Subject: Responses to Staff Comments and Questions on Telecommunications Needs Analysis and Visual Impact Assessment for DP 5050-B

RE: Responses to LUPC Comments on development application for Dallas Plantation Telecommunications Facility

2. Clarify the basis for rating the level of significance for Rangeley Lake and Rangeley Lake State Park (see comment 3,a,i-ii).

Attachment A: Project Map & Viewshed Analysis

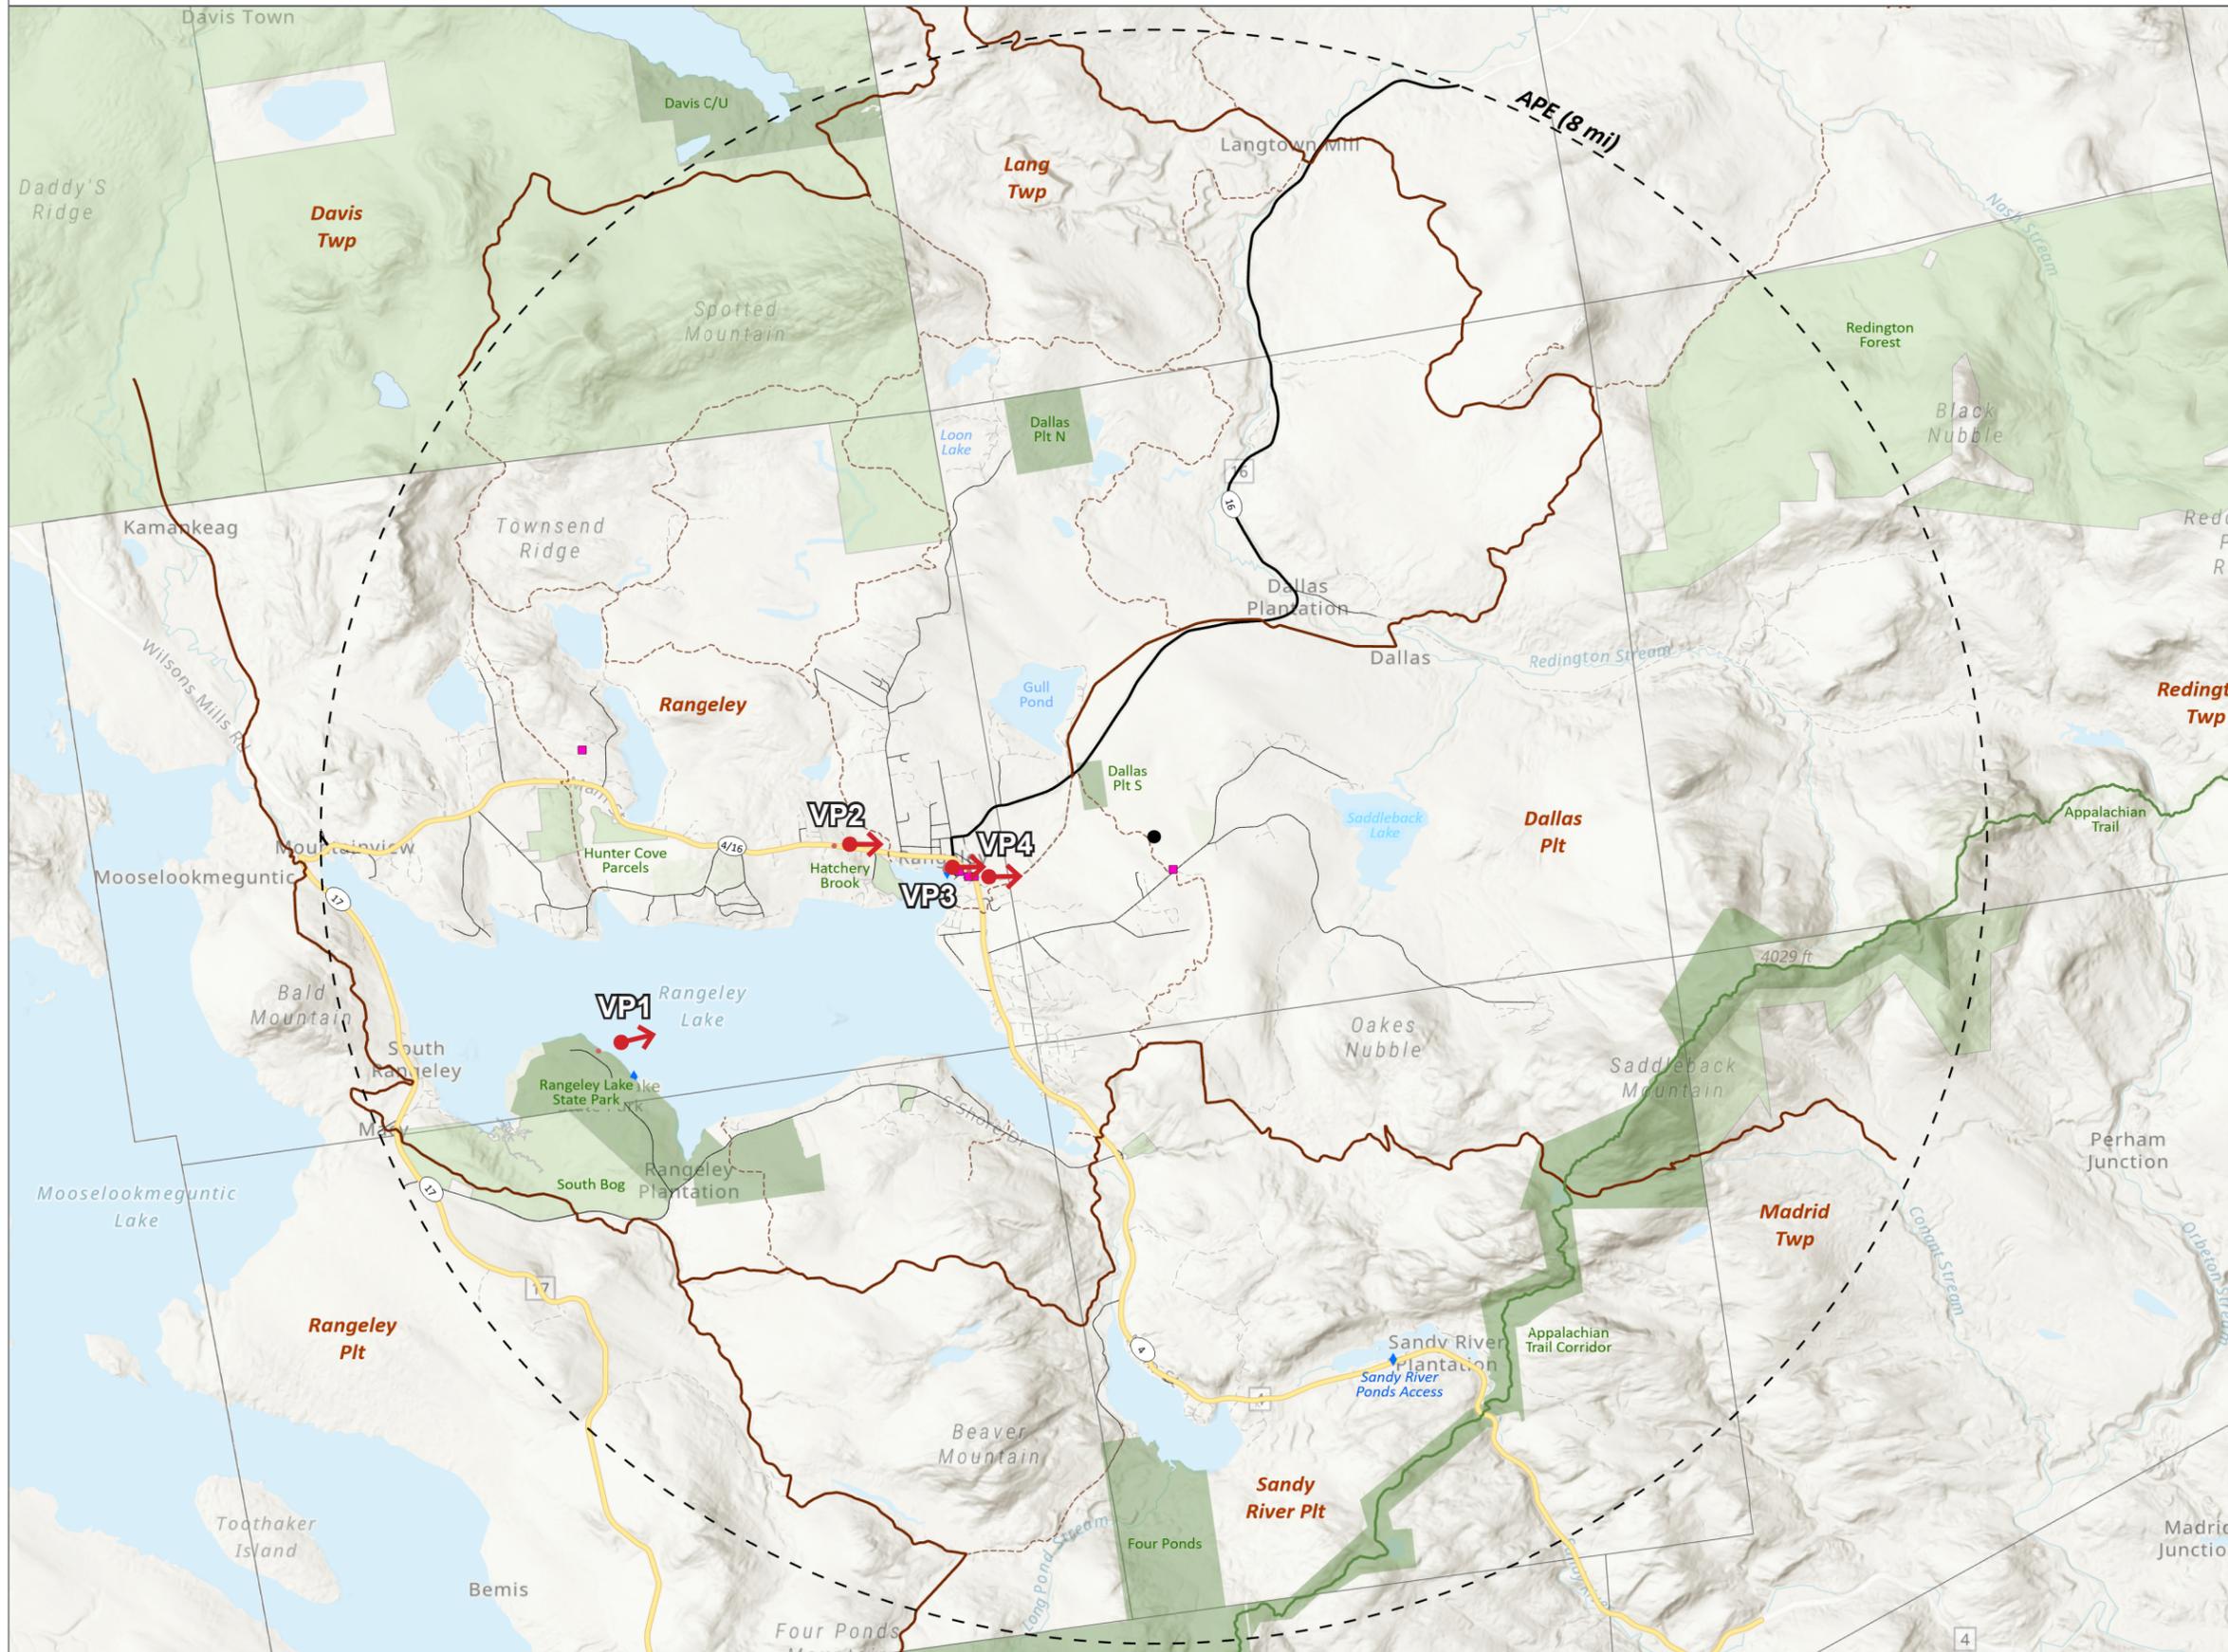
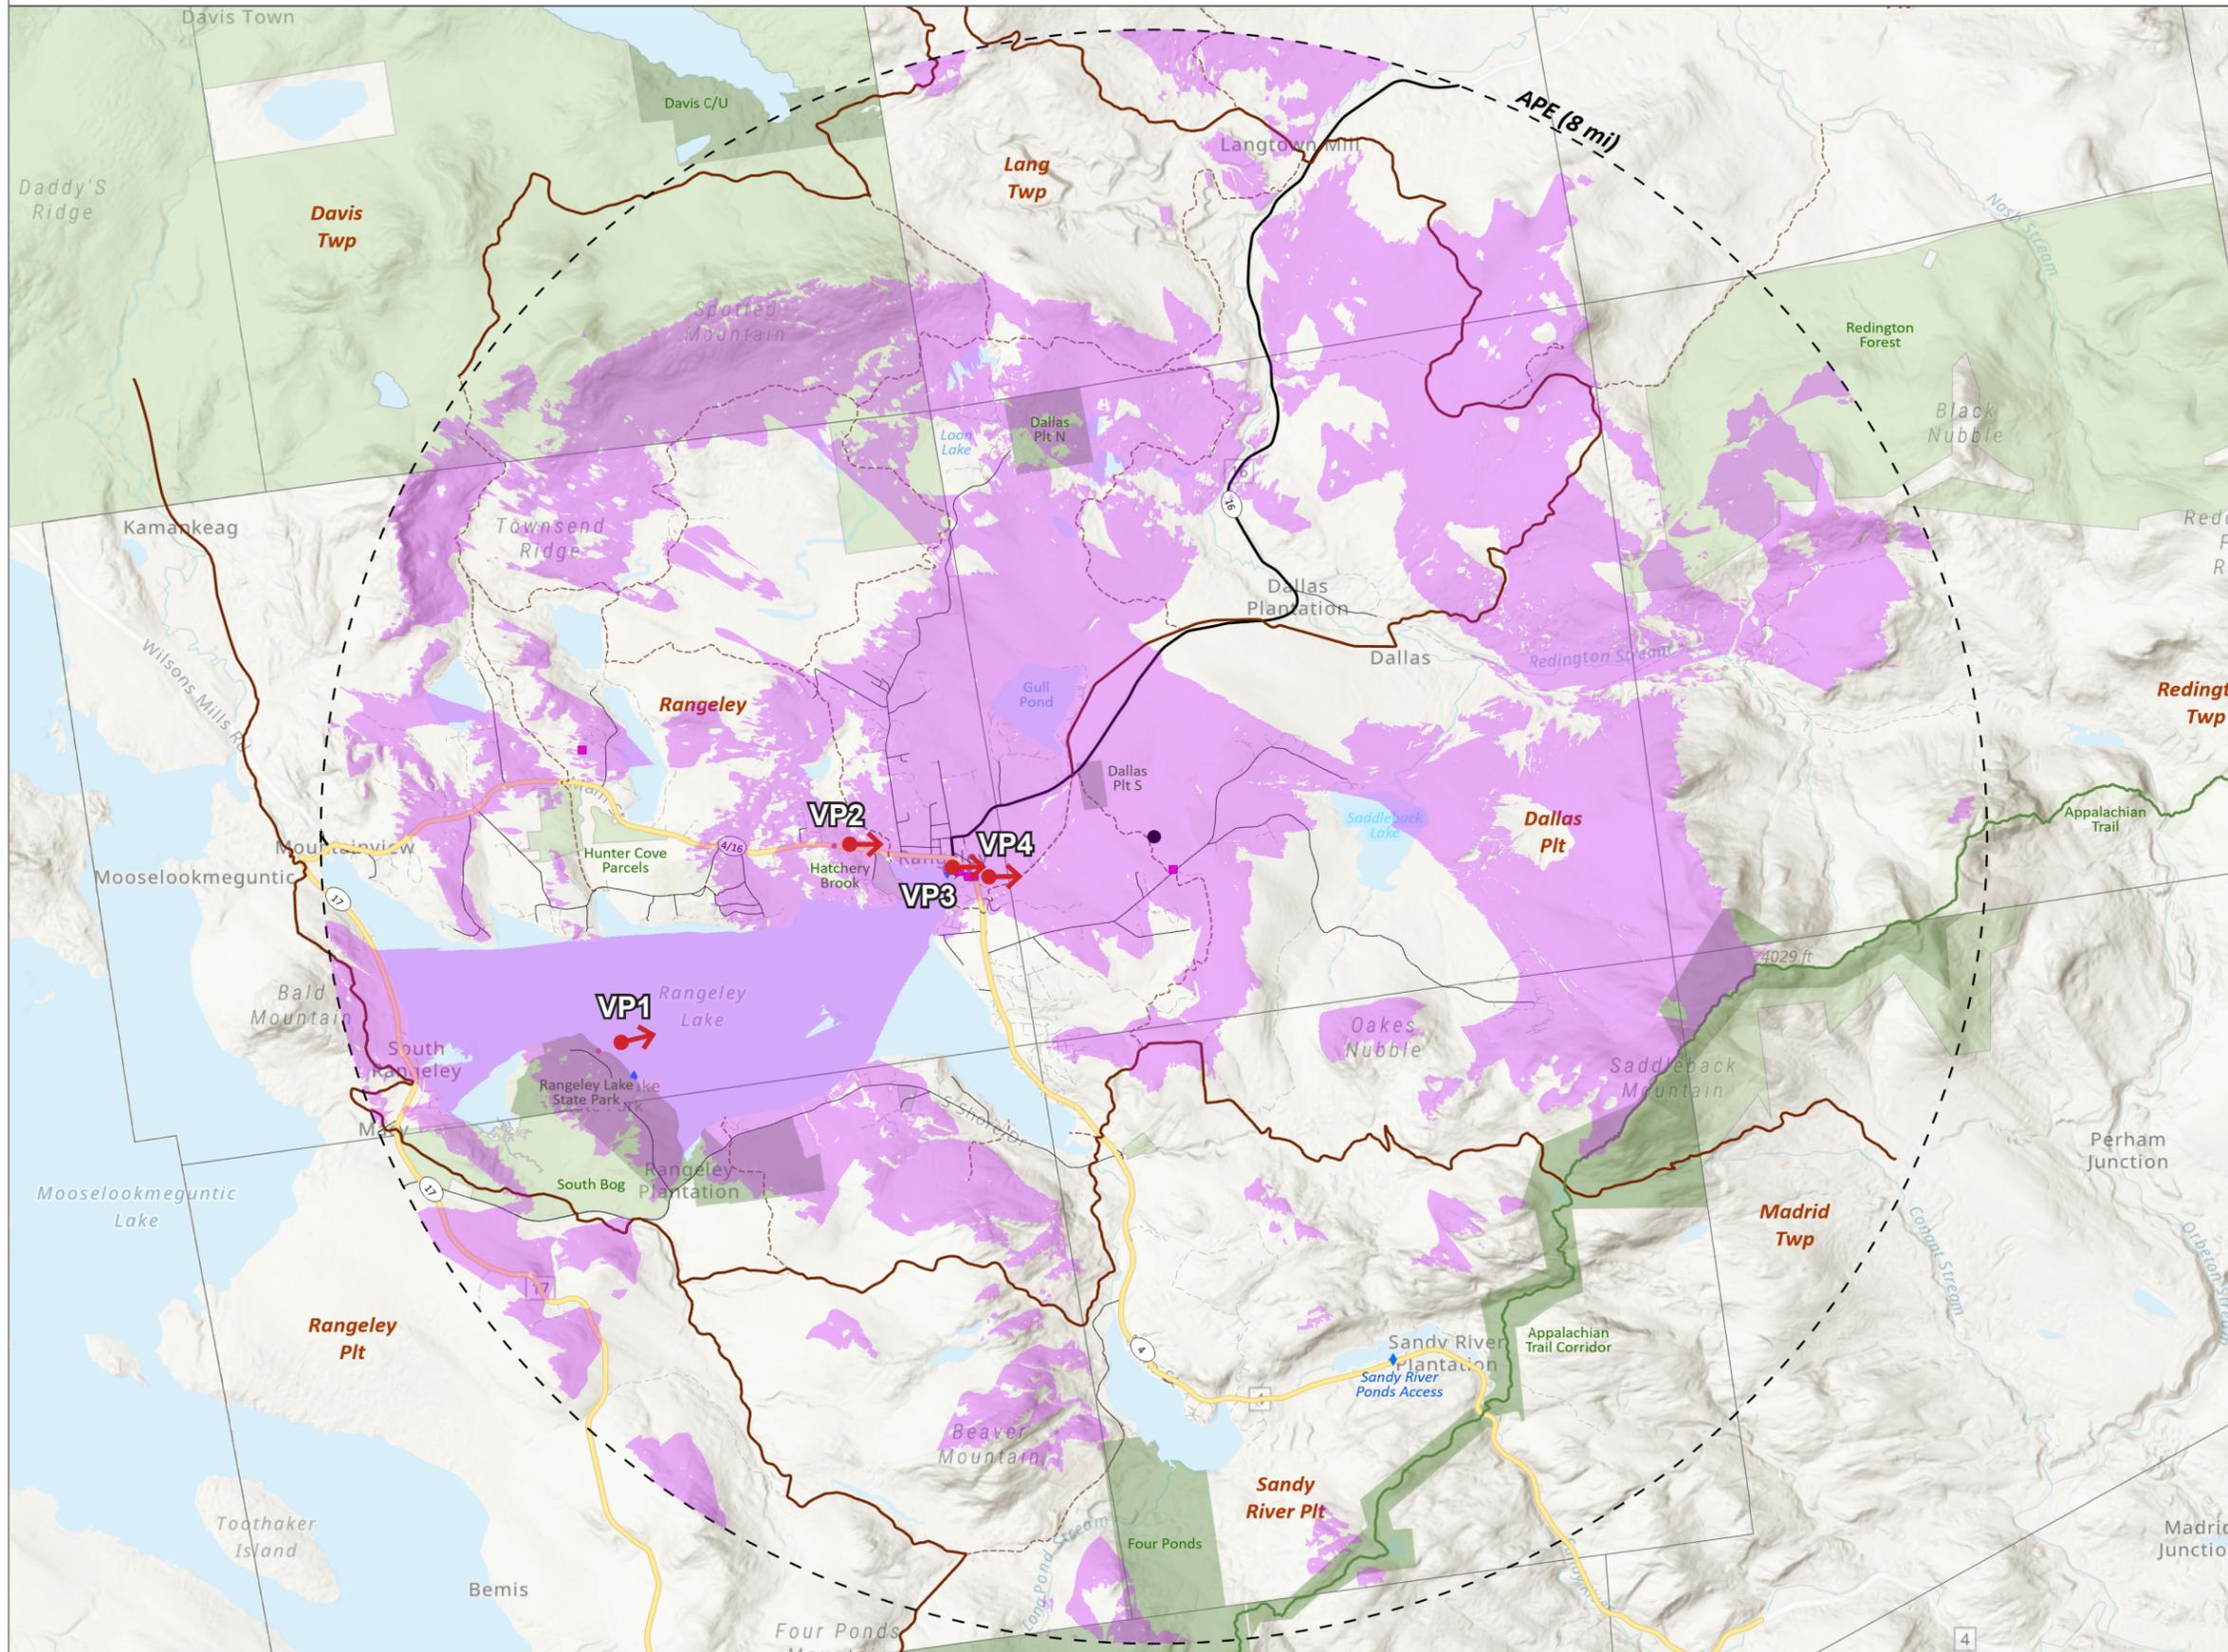
4. Analyze potential visual impacts from Saddleback Lake and Loon Lake – providing photos or a narrative description of conditions on the ground supporting any assertions about potential visual impact (see comment 3,b,ii-iii).

The viewshed analysis prepared by TJD&A indicates that the proposed telecommunications tower would not be visible from either Saddleback Lake or Loon Lake. This analysis is based on computer modeling using LiDAR data to generate both a Digital Surface Model (DSM) and a Digital Terrain Model (DTM). The computer-based viewshed analysis determined whether the top of the tower (where the light is located) would be visible from any point on the landscape within the 8-mile APE. Since the analysis did not show any visibility from either lake, no photographs are provided with this analysis.

Google Earth viewshed modelling indicates that the light may be visible from small portions of each of these waterbodies if vegetation were not present. On Loon Lake this area of potential visibility is located on the western end where there is no development or road access. On Saddleback Lake this viewshed area is located on the northeastern shoreline characterized by a small number of waterfront residences and largely unbroken, wooded shoreline. The accuracy of the Google Earth viewshed modelling cannot be verified, since the source of data and methodology is unknown.
